EXHIBIT 2 - STAFF REPORT

DATE: December 7, 2023
TO: Planning Commission Members
FROM: Tom Schauer, Senior Planner
SUBJECT: Public Hearing – Planned Development Amendment PDA 1-23, Subdivision S 1-23, Three Mile Lane Review TML 5-23

DECISION, CONDITIONS, FINDINGS OF FACT AND CONCLUSIONARY FINDINGS FOR THE APPROVAL OF A PLANNED DEVELOPMENT AMENDMENT, SUBDIVISION TENTATIVE PLAN, AND THREE MILE LANE REVIEW, FOR PROPERTY AT 235 NE DUNN PLACE, TAX LOT R4422CD 01700

DOCKET: PDA 1-23 (Planned Development Amendment)
S 1-23 (Subdivision Tentative Plan)
TML 5-23 (Three Mile Lane Review)

Figure 3a. Proposed Master Plan – Site Plan Summary
(See applications for detailed plans).

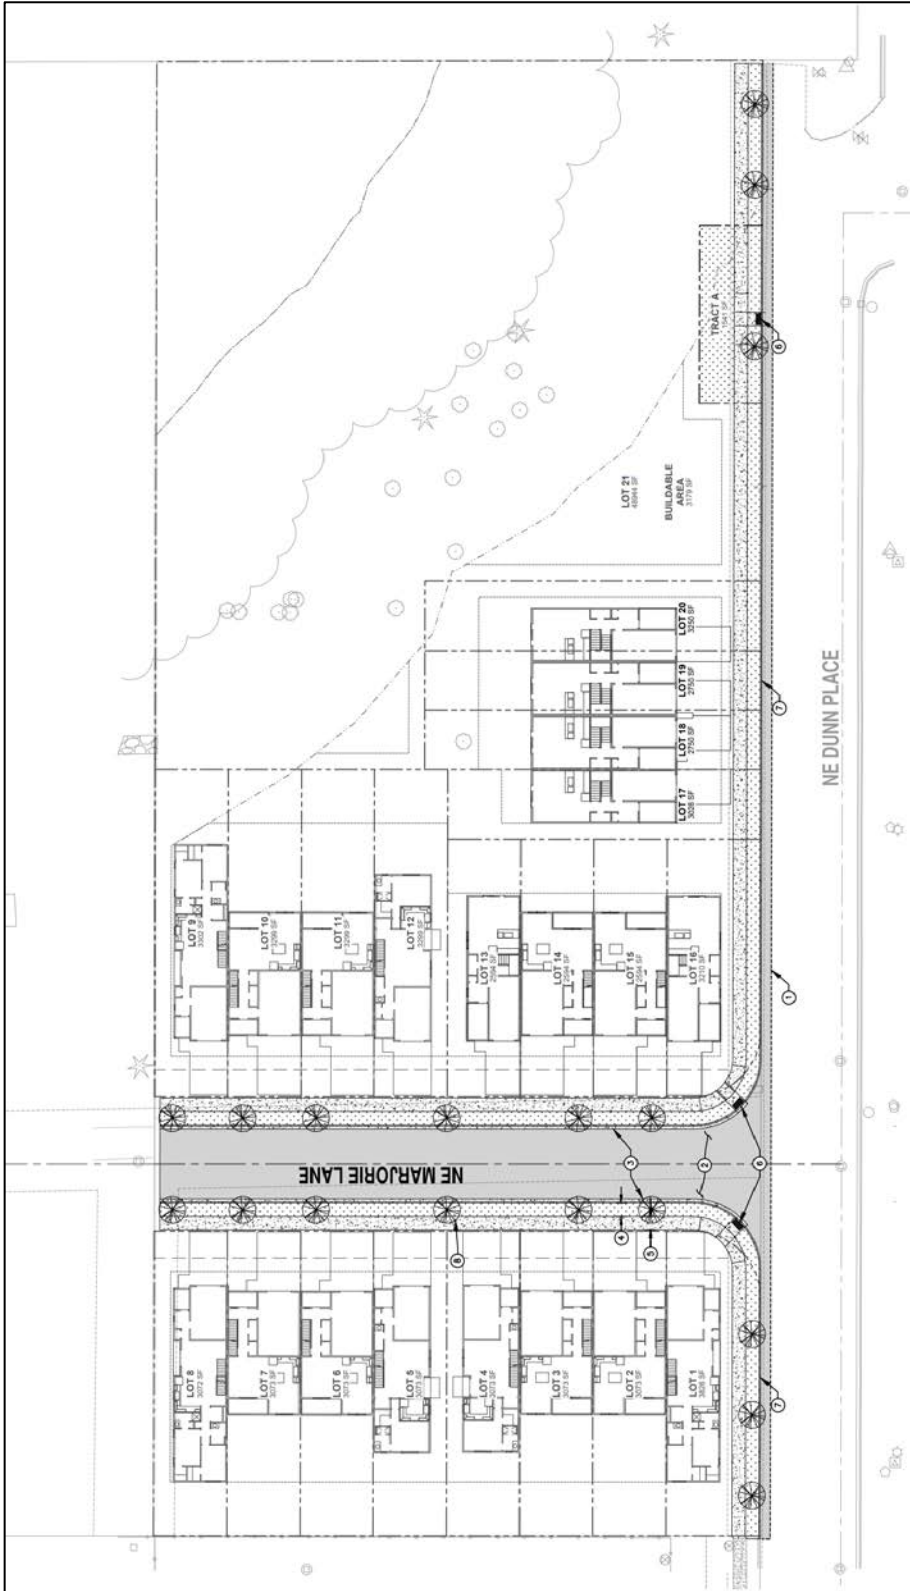
2. Comply with all applicable provisions of Ordinances 4719 and 4956.
3. Revise Tract A to be consistent with the Common Open Space provisions and standards of 17.11.110(C)(3) and (4) relative to the buildable area of the property and consistent with the Three Mile Lane Area Plan Policies.

4. Provide details of the driveways and space for street tree planting locations.
5. The property owner reserve to the City the option for a future easement for a trail along the riparian area.

7. The plan shall incorporate the 60-foot setback shown in the plans.
8. The plans show a portion of the 60-foot setback encroaching into rear yards of lots. The applicant shall record deed restrictions precluding development within the setback areas. These setbacks as shown on the plans shall also become part of the setbacks of the Planned Development Overlay. The deed restrictions shall explicitly list any applicable restrictions

regarding fencing, accessory structures, and other improvements. The applicant shall submit the proposed deed restrictions for review and approval by the Planning Director.

COMPOSITE UTILITY PLAN

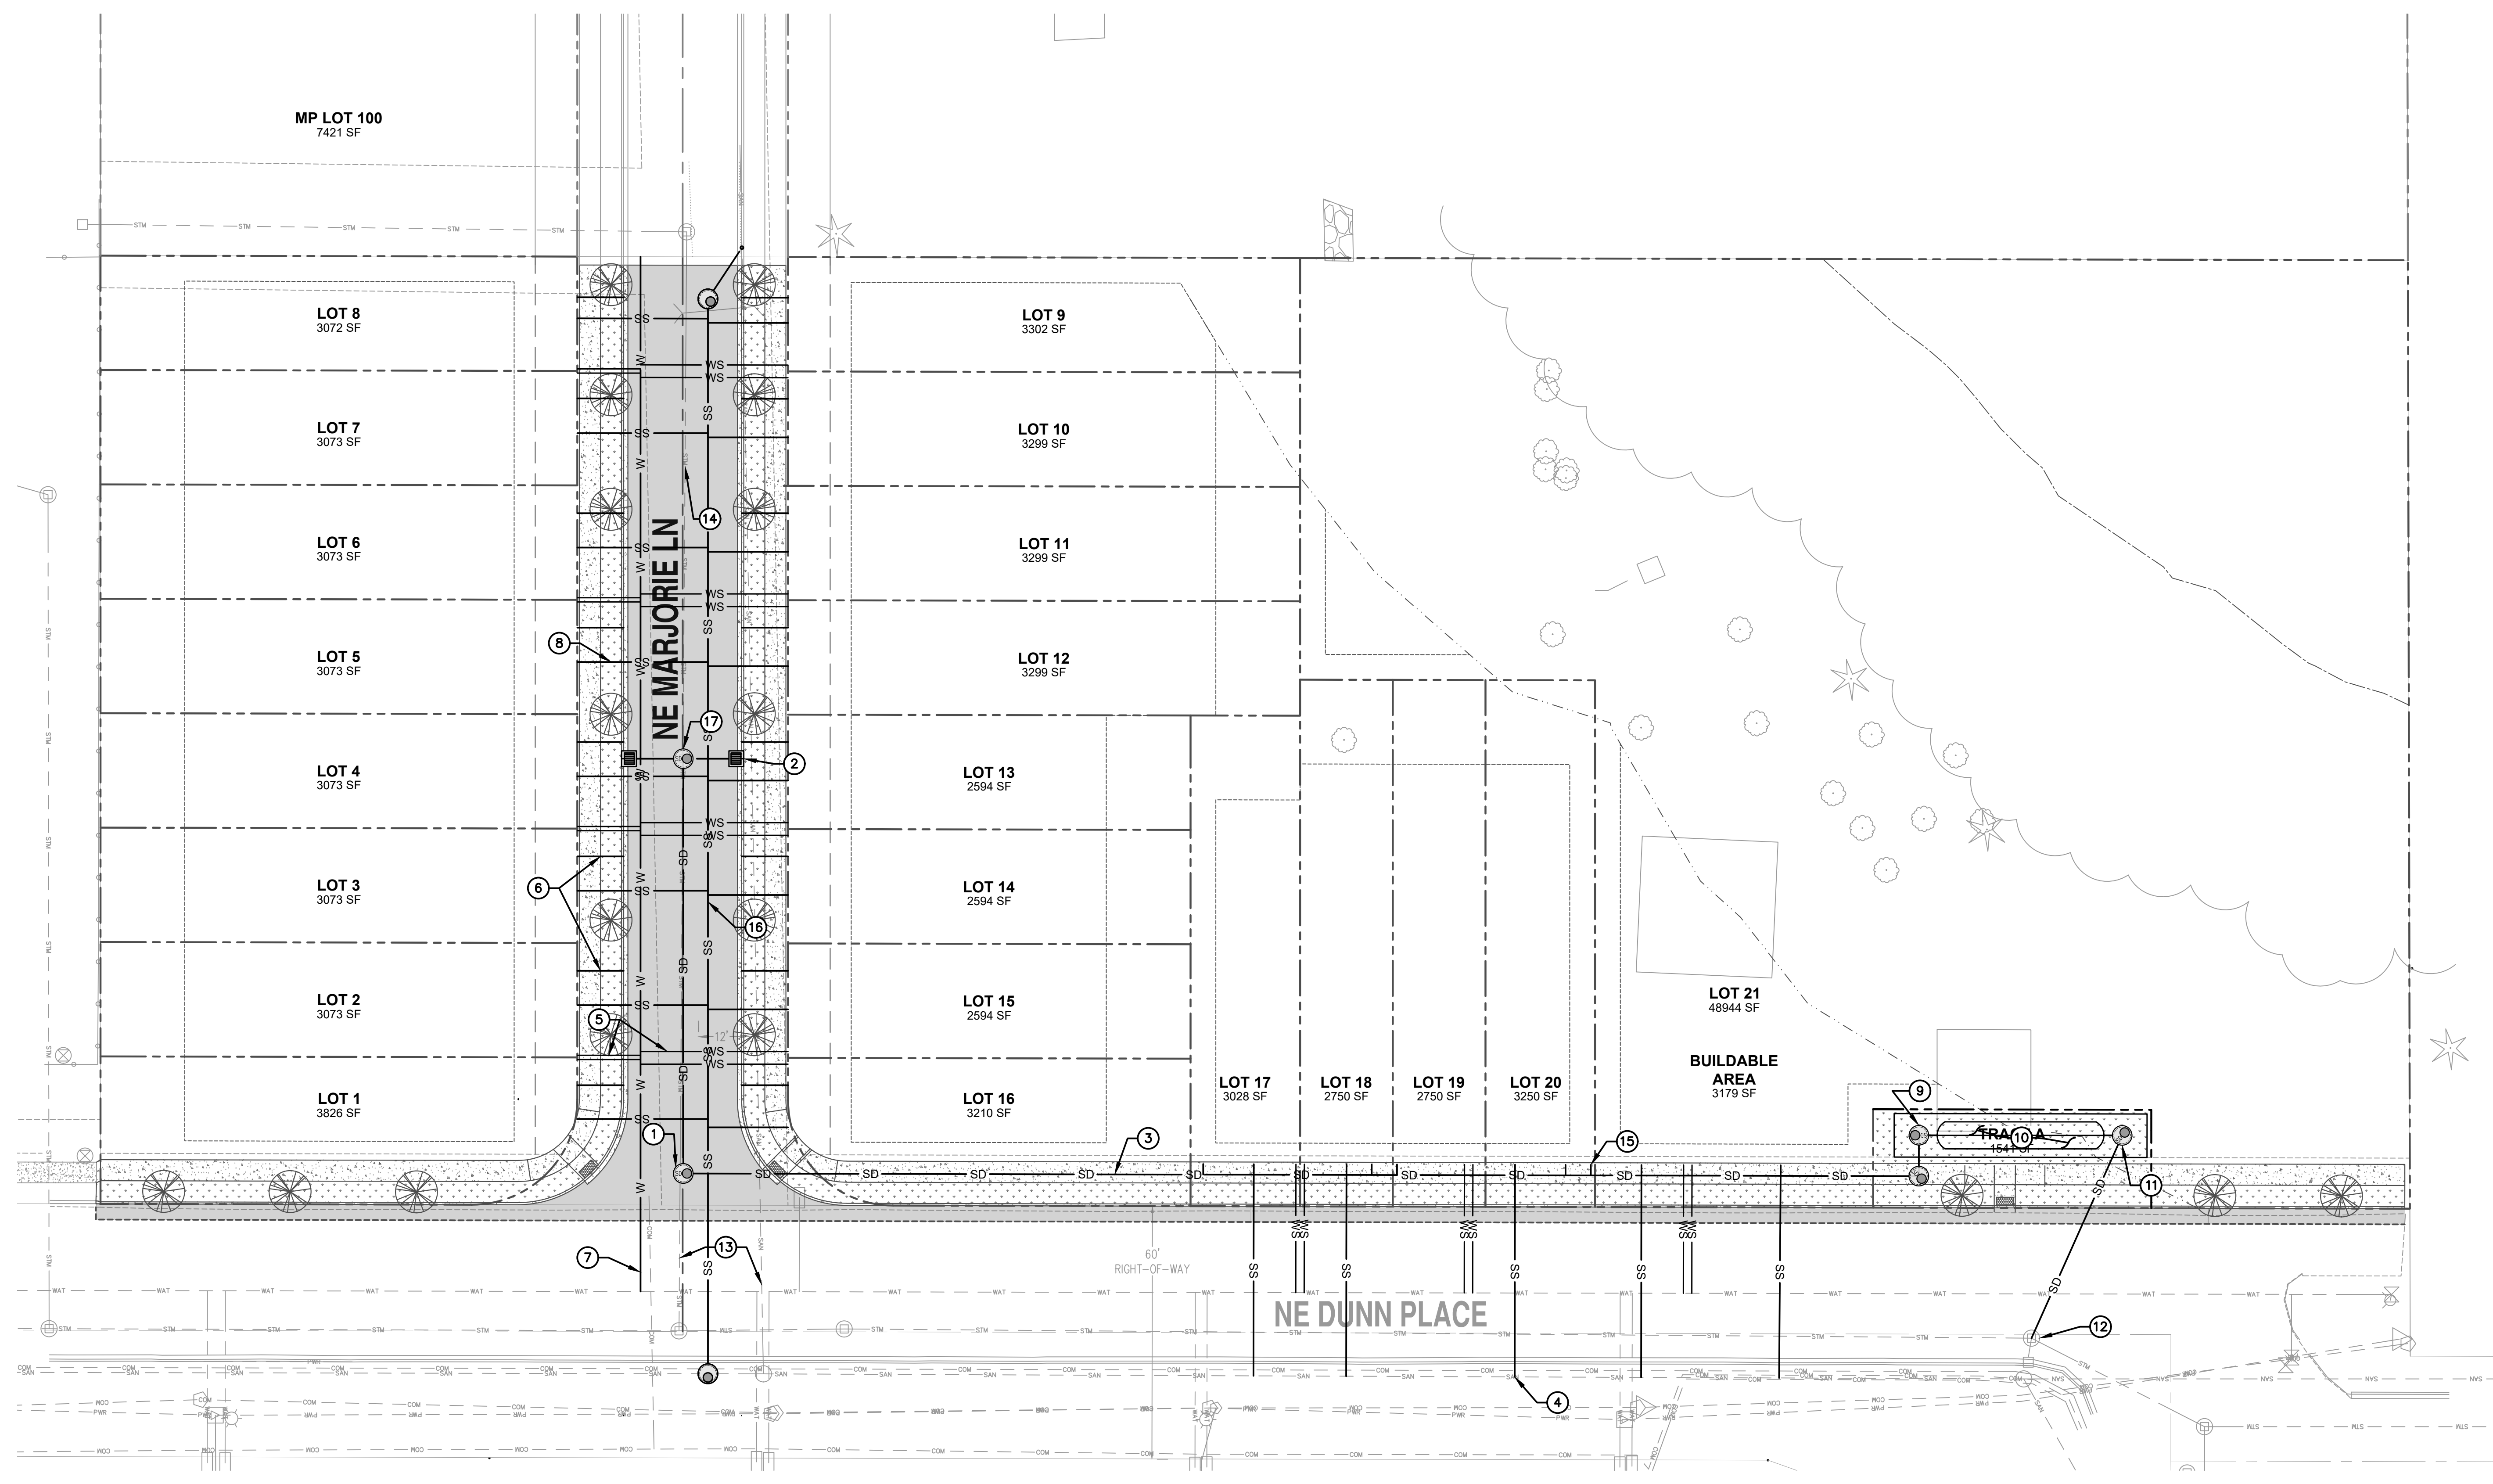
9. At the west terminus of NE Marjorie Lane the sanitary sewer system must provide for future development to the west. The proposed manhole must be located outside the asphalt or a stub out provided for future extension. The existing sewer service will need to be connected to the manhole as shown in the preliminary plans.
